DEVELOPMENT APPLICATION ASSESSMENT REPORT

Application Number:	DA2021/0955
----------------------------	-------------

Responsible Officer:	Gareth David
Land to be developed (Address):	Lot 10 DP 38757, 37 Daly Street BILGOLA PLATEAU NSW 2107
Proposed Development:	Alterations and additions to a dwelling house
Zoning:	E4 Environmental Living
Development Permissible:	Yes
Existing Use Rights:	No
Consent Authority:	Northern Beaches Council
Land and Environment Court Action:	No
Owner:	Renee Louise McAneney
Applicant:	Sean Mcaneney

Photo 2: Existing views from 175 Plateau Road to the south-east (Kitchen - Standing).

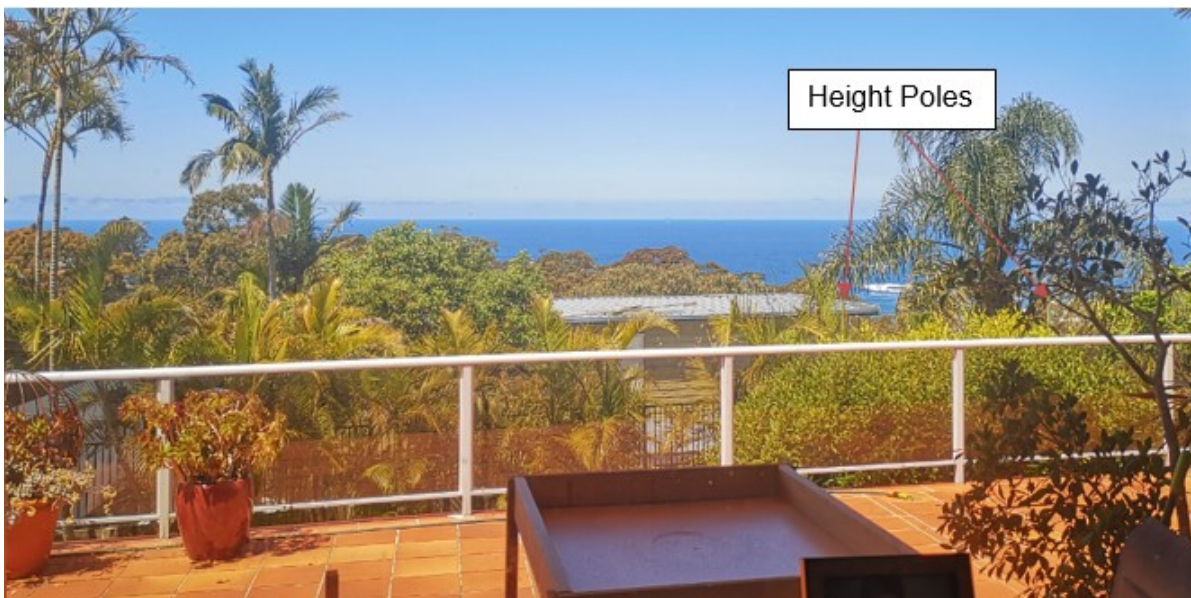
The views of key concern are obtained from the upper floor living room, kitchen, dining room and terrace/balcony and are orientated to the east. This is demonstrated in photos below.

As discussed previously, and as demonstrated in figure 2 above, during the assessment, amended plans were received in order to reduce impacts on views. These amendments deleted the proposed "pop up roof window" element, reduced the height of the south-eastern portion of the roof to under 8.5m by changing the roof design and "stepped" the first floor master bedroom (and roof) an additional 2.15m from the front boundary in order to open up views of Newport Reef.

Figure 1 - Proposed building envelope non-compliance on the northern elevation (highlighted in green).

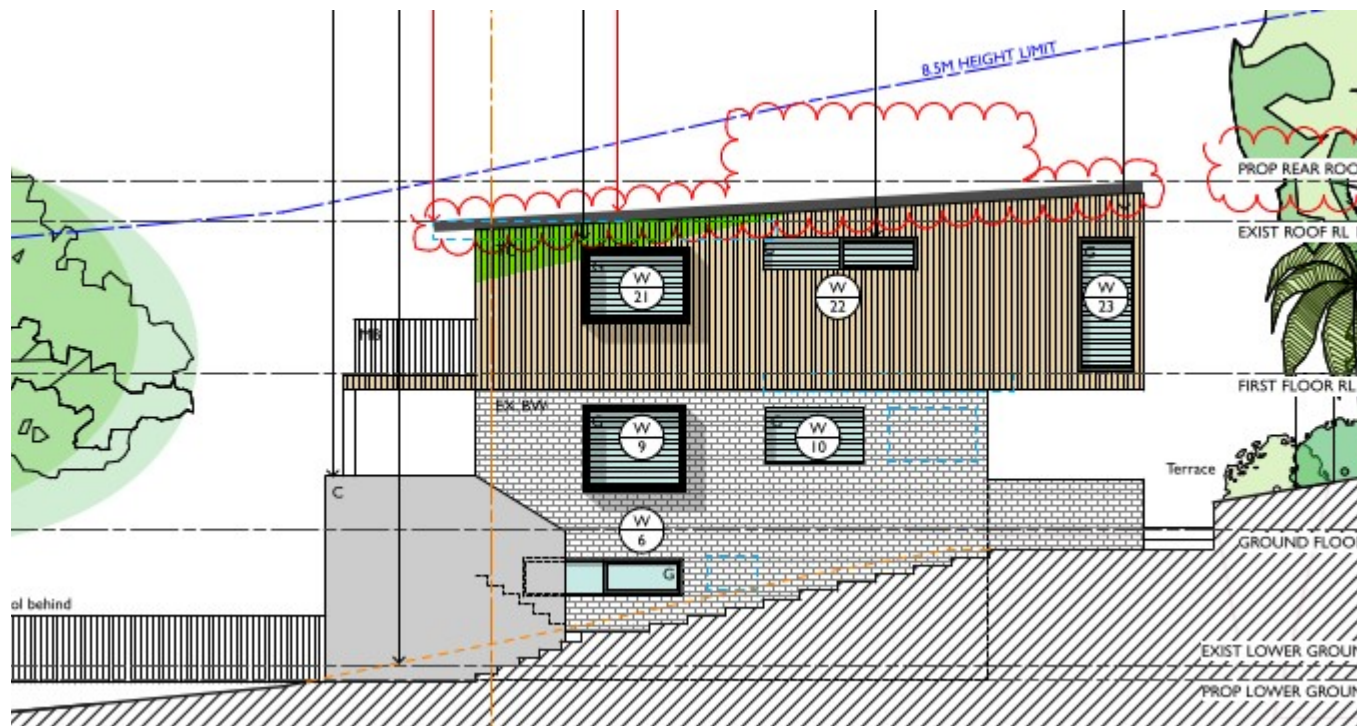
The proposed first floor additions has a minor encroachment into the prescribed building envelope along the northern elevation. This variation is represented in figure 1 below.

This building envelope non-compliance is largely attributed to the slope of the site and the existing built form which currently has an building envelope breach on this elevation.
